# DEVELOPMENT REVIEW BOARD REPORT

### Storage 365 30-DR-2022

Request for approval of a site plan, landscape plan, building elevations, and associated improvements for a new 117,300 square foot internalized storage facility and 5,400 square foot office building on a +/- 2.52-acre site.

**ATTACHMENT #9**

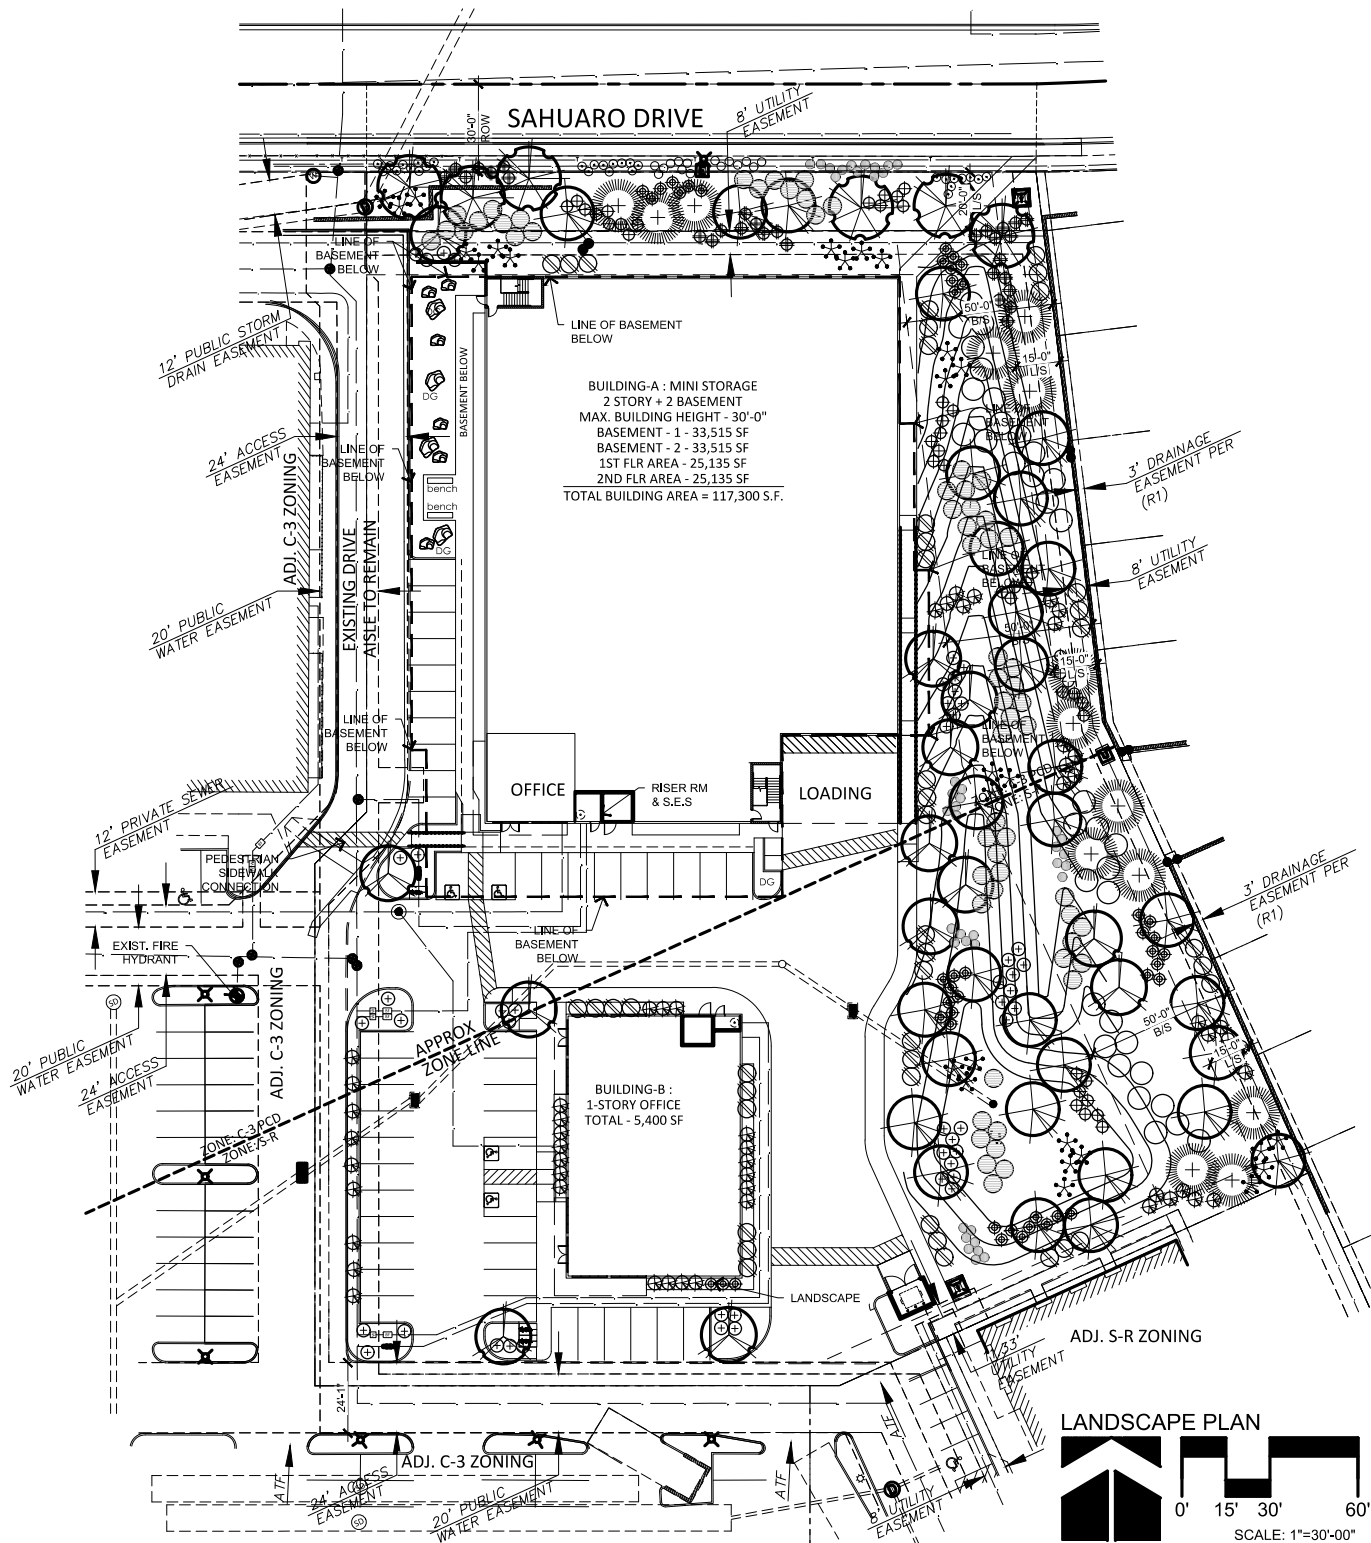
NO LIGHTING IS APPROVED WITH THE SUBMITTAL

THE LANDSCAPE SPECIFICATION SECTION(S) OF THESE PLANS HAVE NOT REVIEWED AND SHALL NOT BE A PART OF THE CITY OF SCOTTSDALE'S APPROVAL.

THORNY TREES, SHRUBS AND CACTI SHALL BE PLANTED SO THAT THEIR MATURE SIZE / CANOPY WILL BE AT LEAST 4 FEET AWAY FROM ANY WALKWAYS OR PARKING AREA CURBING.

**PHOTOMETRIC SITE PLAN**  
SCALE: 1" = 30'-0"

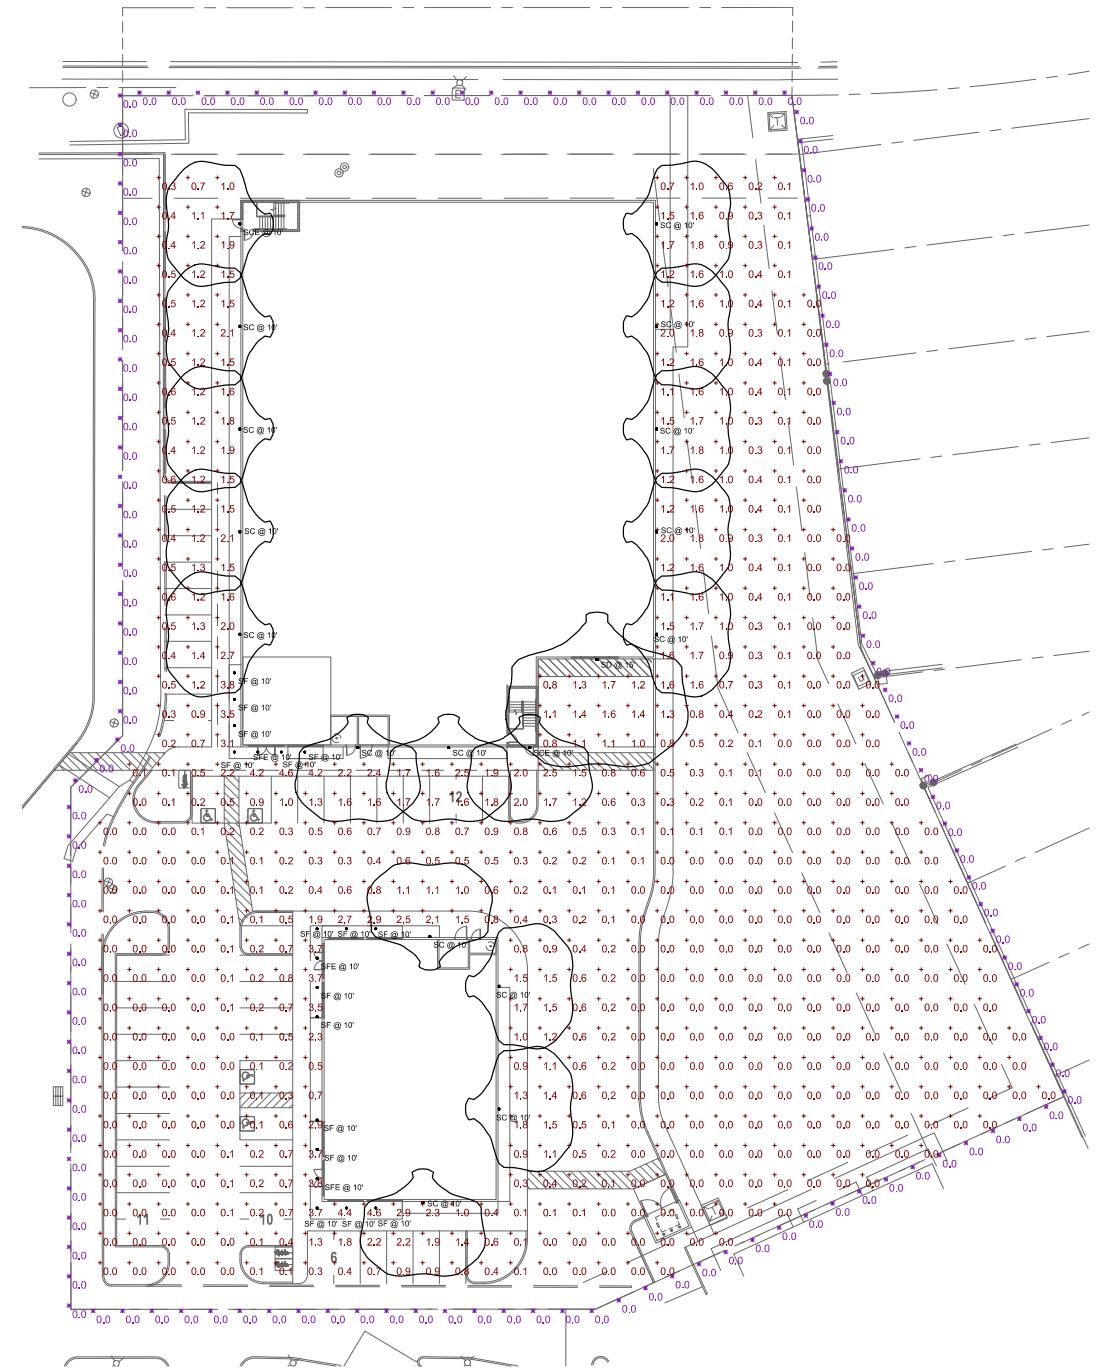
The lighting is something that we have a specific plan prepared for at this stage, so I have attached it here. It is a little odd to read if you have never looked at a photometric plan before, but I would be happy to walk a member of your association through it if you'd like. But let me try and provide some insight via this email. The specific mini numbers that cover the plan represent the number of lighting "footcandles" that exist at a particular spot on the site. So, as it gets closer to your property line, you will see that it drops to zero. That means that we are not going to be bleeding light from our project into your backyards. A little west of that spot, you will see that there is some lighting, though it is dimmer than the lighting that we have directly up against the building. Then, if you look at the building, you will see symbols and letters that represent certain types of lights. Then look at the other part of the plan to the left on page 1, and it specifically tells you what type of lighting fixture is associated with that symbol on the plan. Then when you look at page 2 it shows more detail about that light. So, you will see that along the building on the east side, we have wall lights at 10 feet high that will shine down and cast light directly beneath the light and then also eastward into the landscape area, stopping short of the shared property line.
